ADDENDUM

Project: Secure Entrances Addendum No.: 01

Dixon, Providence and Sebree

Owner: Webster County Schools Project Number: 2407-246

FIRST FLOOR PLAN- PROVIDENCE

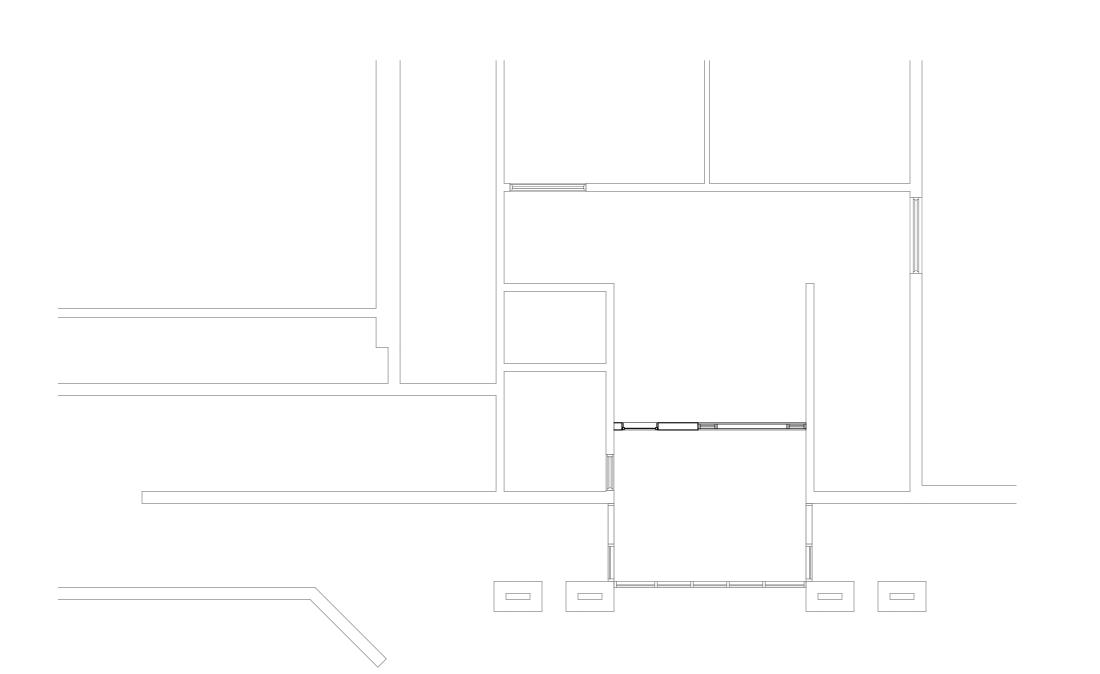
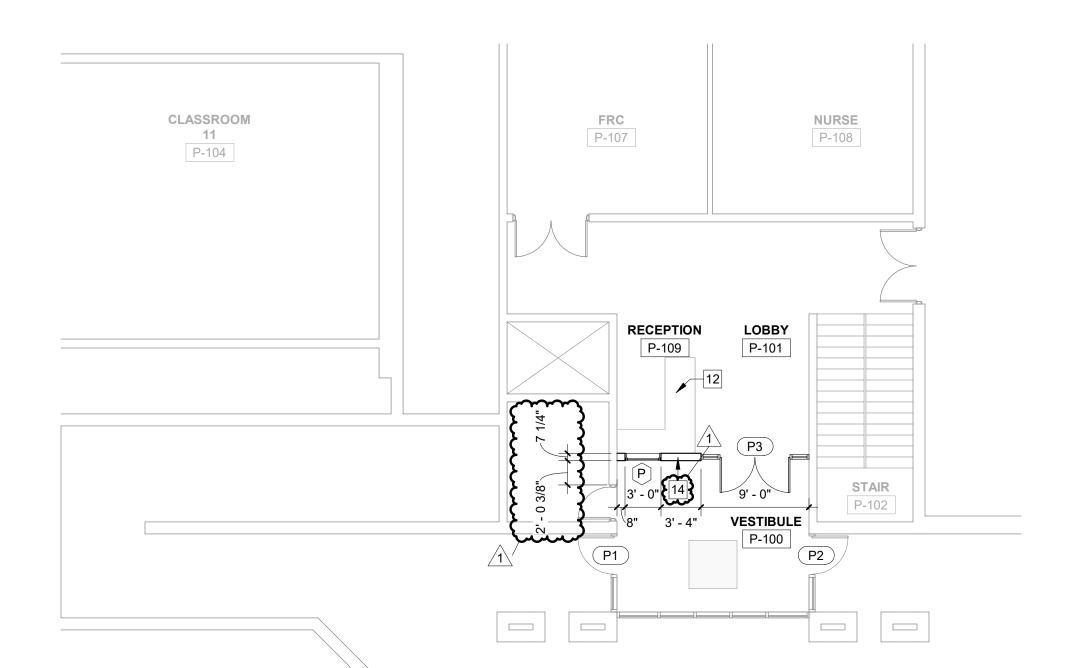
- 1-5 Sheet A1.1 FLOOR AND CEILING PLANS: See attached sheet for revisions to Providence reference notes and wall dimensions.
- 1-6 Sheet E1.1 ELECTRICAL LEGEND AND BUSSING DIAGRAMS: See attached sheet for revisions to Electrical Legend Technology.
- 1-7 Sheet E2.1 POWER AND SYSTEMS PLANS: See attached sheet for revisions to door hardware wiring.
